Addendum No. 01

TO: PLANS AND SPECIFICATIONS FOR STATE OF MISSOURI

Six New Full Service Cabins
Johnson's Shut-Ins State Park
Middle Brooke, MO
Project No: X2206-01

2
TYPICAL EXTERIOR WALL SECTION
SCALE: 3/4"=1'-0"

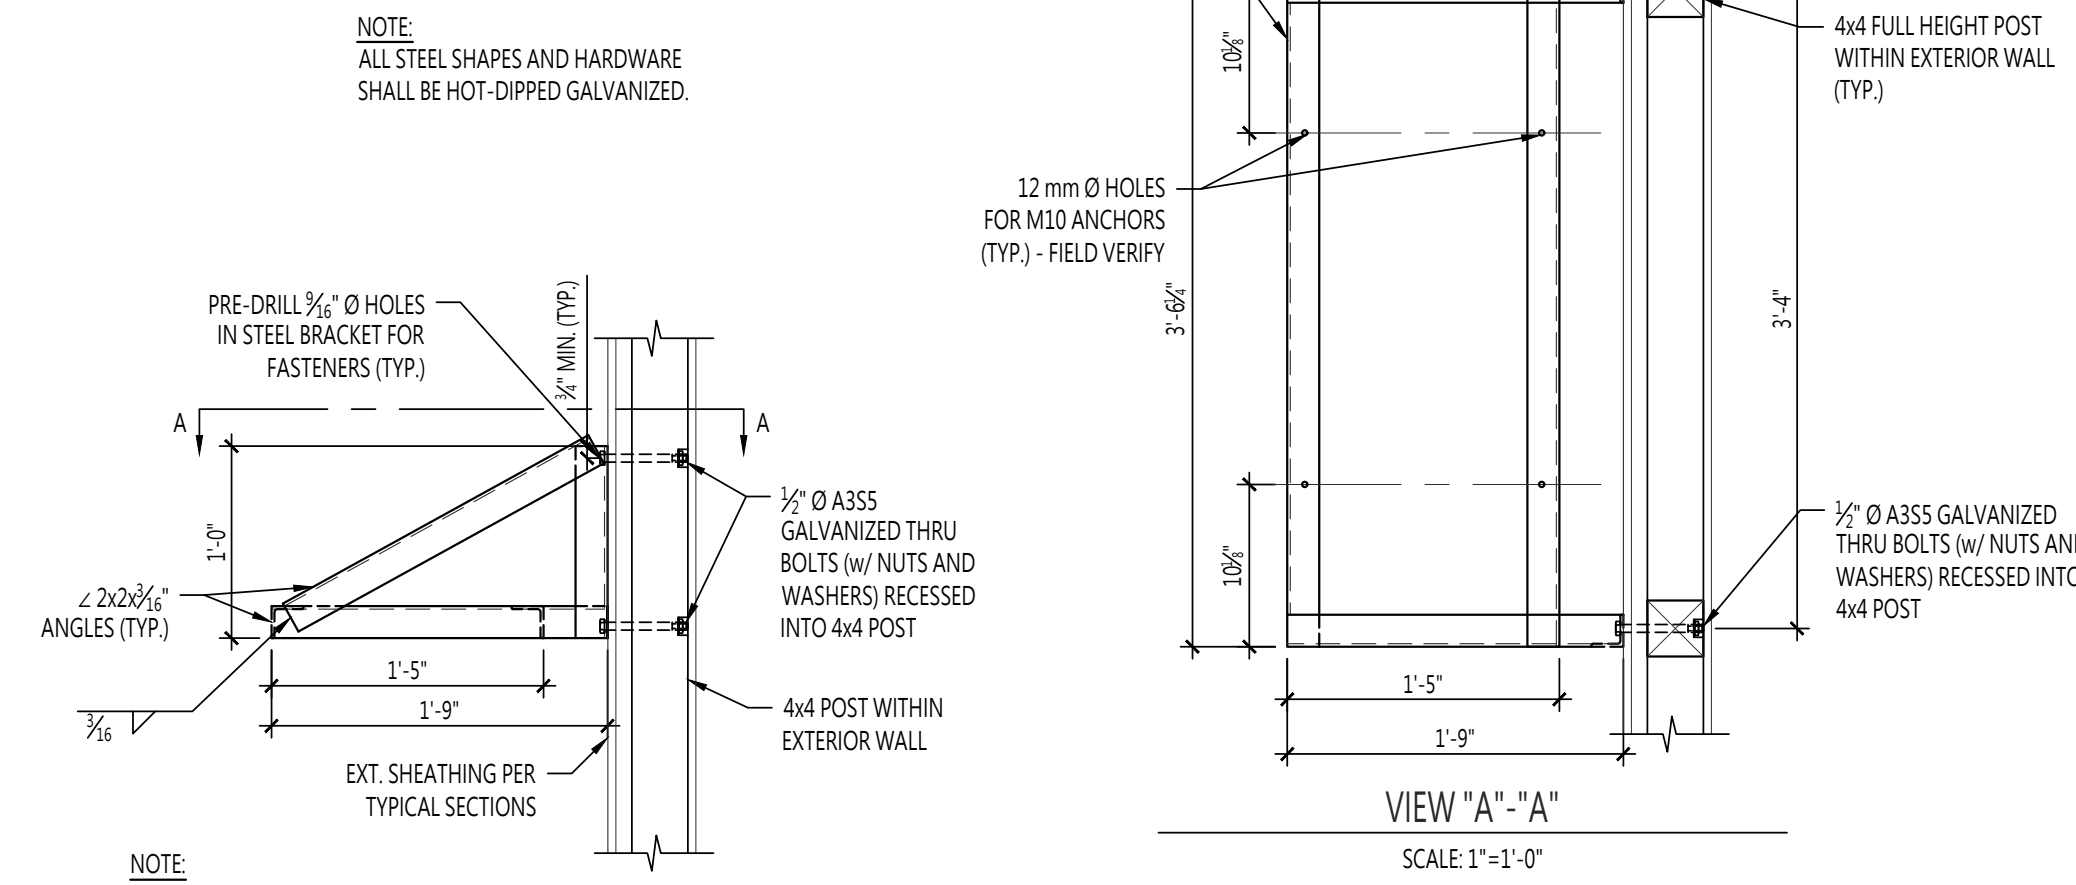
ALL FOOTINGS TO EXTEND TO A MINIMUM OF 4.5 FEET BELOW GRADE,
UNLESS NOTED OTHERWISE.
5. Sheet S3.0 – See Attached Revised Sheet S3.0
 - a. REVISE Detail 11 to indicate floor sheathing extending below sill plate.
6. Sheet S3.1 – See Attached Revised Sheet S3.1
 - a. REVISE Detail 2 to indicate floor sheathing extending below sill plate.
 - b. REVISE Detail 2 to indicate 2 – 2” x 4” Top Plate.

Answer: Yes.
- h. Question: Details on S3.1 appear to show the subfloor sheathing running into the exterior plate, not under it. A detail shows it under the plates.

Answer: Floor sheathing shall extend under the wall bottom plate.
- i. Question: Exterior dimensions are confusing. For example: Sheet A1.0 detail 1 appears to show a dimension of 31’6” to the inside of the walls. A3.2 detail 1 gives a wall thickness of 5 3/8”. That makes the building 32’ 4 3/4”. The other side of the same of the same drawing shows (4) 8’ dimensions (32’) outside to outside. Detail 2 on S1.0 shows 4 piers 8’ on center. That would be 32’ from center to center of the outside piers and the 6 x 12 beam. The beam appears to line up with the outside of the stud so the overall dimension would be 32’ 6”.
